## Fwd: Incorrect Thermal broken Aluminum Joinery: 2 Rapare St. Job No.27363 - JSR Construction.

Subject: Incorrect Thermal broken Aluminum Joinery: 2 Rapare St. Job No.27363 - JSR Construction.

Quote No. -27363- Ver 29

Photo 2 – Typical joint between the vertical frame of the sliding door and the horizontal frame of the window shows that the shared frame between the door and the window do not have the thermally broken strip.

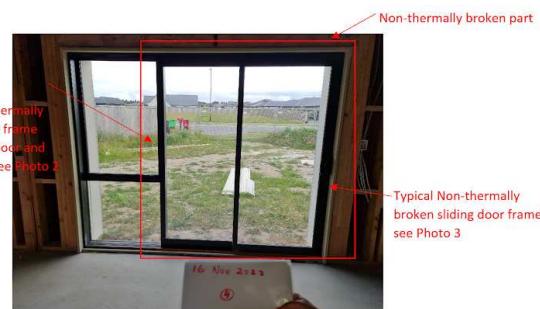
- b) Photo 2 – Typical joint between the vertical frame of the sliding door and the horizontal frame of the window shows that the shared frame between the door and the window do not have the thermally broken strip.

Photo 1 – Indicating the non-thermally broken parts of the Sliding Door “Lounge D6” (Door number referred to the attached quote no. 27363) (Trim Size: 2130 x 2700; Area: 5.751 m sq.)

Photo 3 – Typical slide door frame shows that the slide door does not have thermally broken

1. We are prepared to change the six Sliding Door Stiles on site to the Thermally Broken Stiles but the homeowner needs to be aware of the potential for Thermal Bowing especially being a dark powder-coat colour and therefore does not carry a warranty.
2. Credit back the difference in cost between the standard Aluminium Stiles and the Thermally Broken Stiles which works out to be \$21.50 + GST per Stile. Total \$129.00 + GST
3. More than happy for yourself and the homeowner to come into our Office and discuss the options and homeowner's expectations.

1. We are prepared to change the six Sliding Door Stiles on site to the Thermally Broken Stiles but the homeowner needs to be aware of the potential for Thermal Bowing especially being a dark powder-coat colour and therefore does not carry a warranty.
2. Credit back the difference in cost between the standard Aluminium Stiles and the Thermally Broken Stiles which works out to be \$21.50 + GST per Stile. Total \$129.00 + GST
3. More than happy for yourself and the homeowner to come into our Office and discuss the options and homeowner's expectations.

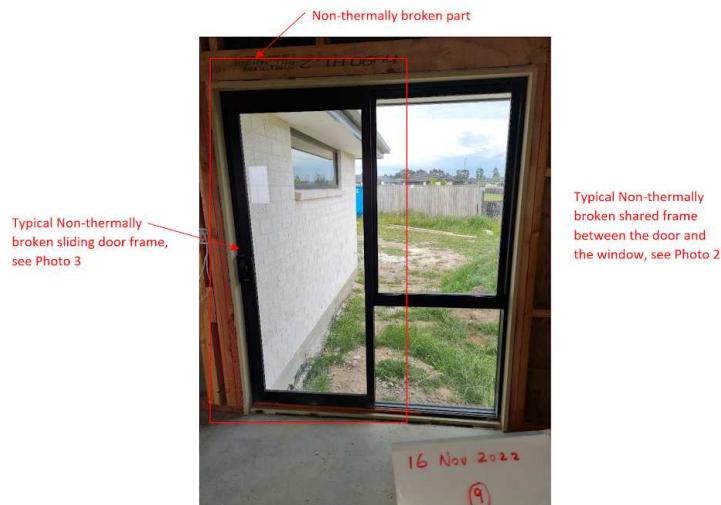
Photo 4 – Indicating the non-thermally broken parts of the Sliding Door “Living D6” (Door number referred to the attached quote no. 27363) (Trim Size: 2130 x 2700; Area: 5.751 m sq.)

Photo 5 – Indicating the non-thermally broken parts of the Sliding Door “Dining D6” (Door number referred to the attached quote no. 27363) (Trim Size: 2130 x 2700; Area: 5.751 m sq.)

Photo 6 – Indicating the non-thermally broken parts of the Sliding Door "Bedroom 3 D5" (Door

Photo 7 – Indicating the non-thermally broken parts of the Sliding Door "Bedroom 2 D4" (Door number referred to the attached quote no. 27363) (Trim Size: 2130 x 1800; Area: 3.834 m sq.)

Photo 9 – Indicating the non-thermally broken parts of the Sliding Door "Master Bedroom D3" (Door number referred to the attached quote no. 27363) (Trim Size: 2130 x 1800; Area: 3.834 m sq.)

Photo 12 – Indicating the non-thermally broken parts of the Sliding Door "Bedroom 4 D4" (Door number referred to the attached quote no. 27363) (Trim Size: 2130 x 1800; Area: 3.834 m sq.)

Photo 8 – Indicating uncertain thermally broken window "Bedroom 2 W5" (Door number referred to the attached quote no. 27363) (Trim Size: 600 x 2400; Area: 1.37 m sq.)

Photo 10 – Indicating uncertain thermally broken window "Master Bedroom W4" (Door number referred to the attached quote no. 27363) (Trim Size: 600 x 2400; Area: 1.37 m sq.)

Photo 11 – Indicating uncertain thermally broken window “Master Bedroom W3” (Door number referred to the attached quote no. 27363) (Trim Size: 1000 x 1500; Area: 1.5 m sq.)

Figure 1 - Photo location plan

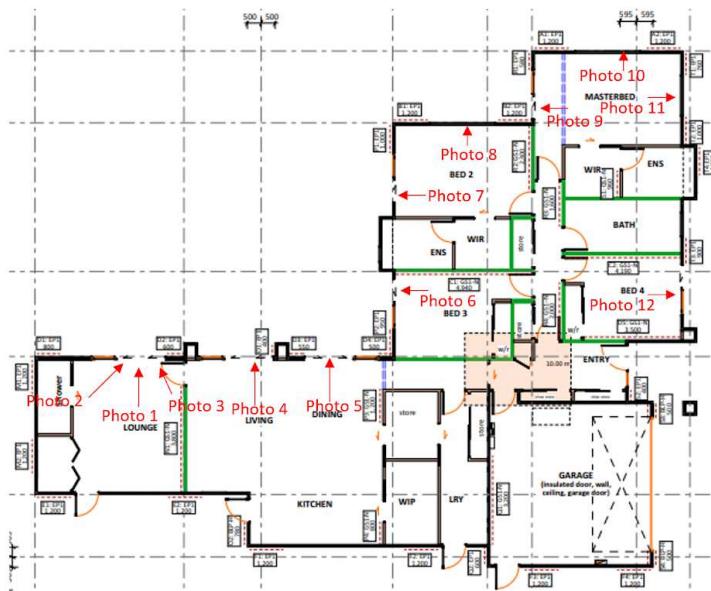
- 1) The parts of the windows and doors frames do not have the thermally broken strip. These windows and doors make up 59% of the area of all the aluminium joinery products. The total area of these problematic aluminium joinery is 28.8 m sq. The total area of all aluminium joinery products is 48.6 m sq. These problematic products are shown in the following photos (note that the photos and the location plan are given at the end of this email):

- 2) The frames of the windows that we are not sure if they are thermally broken or not since the depths of those window frames seems to be smaller than others 32% of the thermally broken joinery by comparing the distances between the frames and the internal and external walls. The total area of these uncertain aluminium joinery is 4.2 m sq. (8.7 % of the total area). These products are shown in the following photos:

Photo 1 – Indicating the non-thermally broken parts of the Sliding Door “Lounge D6” (Door number referred to the attached quote no. 27363) (Trim Size: 2130 x 2700; Area: 5.751 m sq.)

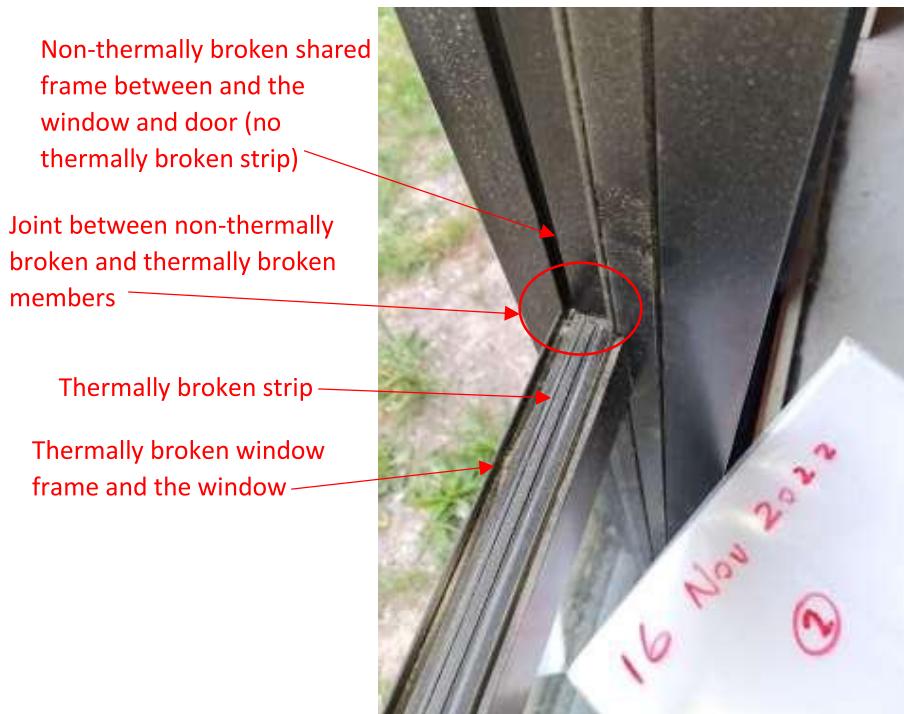
Photo 2 – Typical joint between the vertical frame of the sliding door and the horizontal frame of the window shows that the shared frame between the door and the window do not have the thermally broken strip.

Photo 3 – Typical slide door frame shows that the slide door does not have thermally broken strip

Figure 1 - Photo location plan

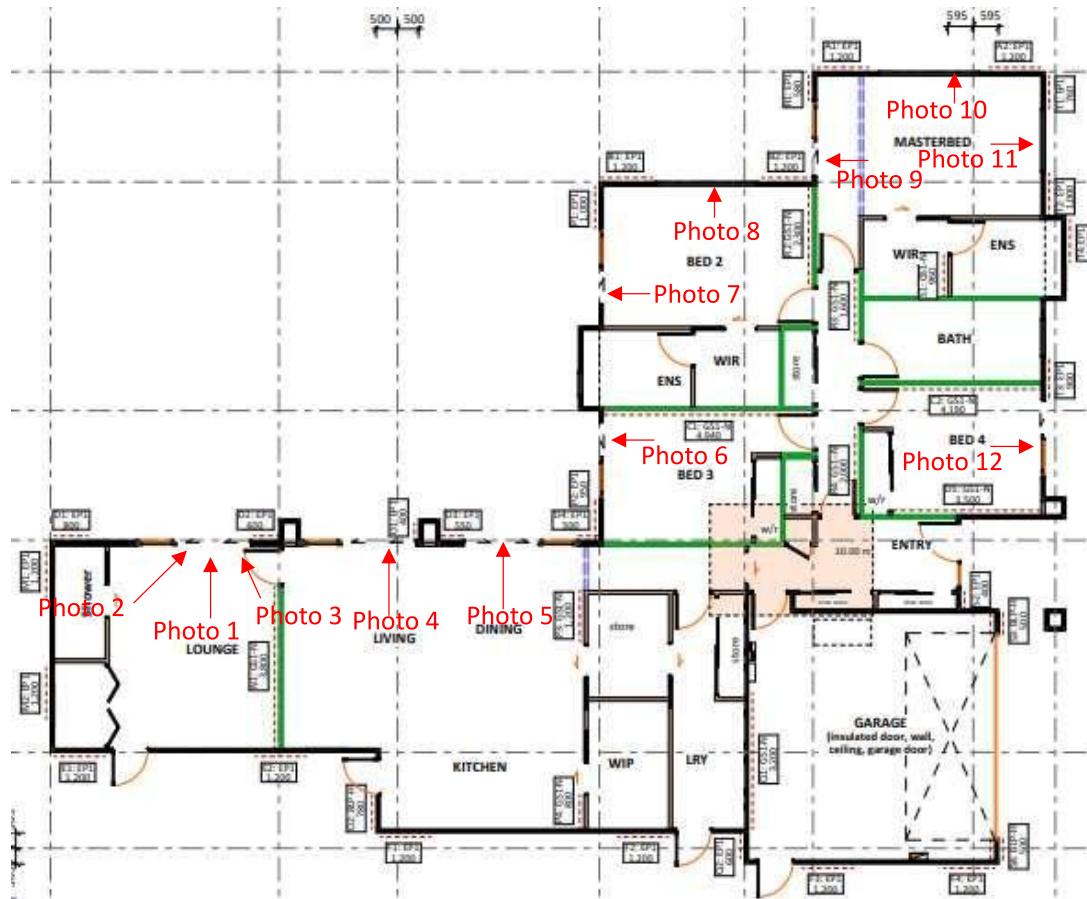
- 1) The parts of the windows and doors frames do not have the thermally broken strip. These windows and doors make up 59% of the area of all the aluminium joinery products. The total area of these problematic aluminium joinery is 28.8 m sq. The total area of all aluminium joinery products is 48.6 m sq. These problematic products are shown in the following photos (note that the photos and the location plan are given at the end of this email):
  - a) Photo 1 – Indicating the non-thermally broken parts of the Sliding Door “Lounge D6” (Door number referred to the attached quote no. 27363) (Trim Size: 2130 x 2700; Area: 5.751 m sq.)
  - b) Photo 2 – Typical joint between the vertical frame of the sliding door and the horizontal frame of the window shows that the shared frame between the door and the window do not have the thermally broken strip.

- 2) The frames of the windows that we are not sure if they are thermally broken or not since the depths of those window frames seems to be smaller than others 32% of the thermally broken joinery by comparing the distances between the frames and the internal and external walls. The total area of these uncertain aluminium joinery is 4.2 m sq. (8.7 % of the total area). These products are shown in the following photos:
